**THE
NATIONAL
BOARD**
OF BOILER AND
PRESSURE VESSEL
INSPECTORS

NATIONAL BOARD INSPECTION CODE COMMITTEE

MINUTES

Meeting of July 16th, 2020
Louisville, KY

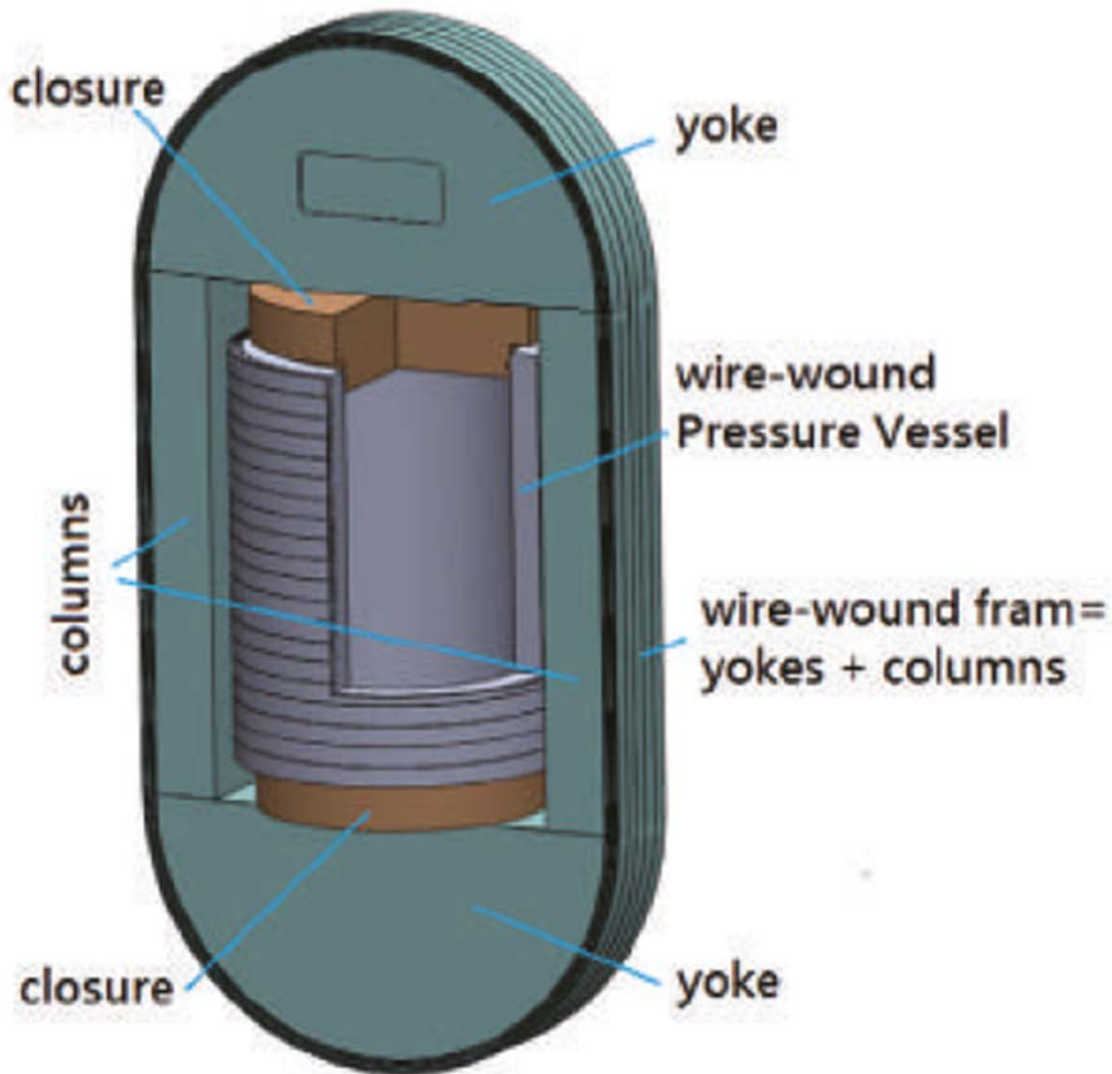
A Section VIII, Division 3 pressure vessel is made from machined forgings with no welding. The pressure retaining items are a cylinder, end closures and a frame that holds the end closures in place. A sketch is provided.

The original ASME Data Report does not reflect the correct "Part" serial number when it is replaced with no documentation. ASME Section VIII, Division 3 Code stamped "Parts" are being replaced with new ASME Code stamped "Parts" without any documentation. The original ASME Data Report listed the original "Part" serial number and will no longer be accurate if the original "Part" is replaced.

Committee’s Reply	<p>R1: Yes, see Part 3, 3.3.3.h</p> <p>R2: Yes.</p>
Rationale	<p>The definition of “Mechanical Assembly” in Part 3, Section 9, includes language related to restoration of the pressure retaining boundary. The examples of repairs described in Part 3, 3.3.3.h involving use of replacement parts are not limited to installation by welding.</p> <p>Per Part 3, Section 1.5.1.h, the Quality System shall include controls for repairs and alterations, including mechanical assembly, as applicable.</p> <p>Per Part 3, Section 5.12.4.1, use of the Remarks Section on Form R-1 is available to include supplemental information not otherwise covered on the form.</p>
SC Vote	
NBIC Vote	
Negative Vote Comments
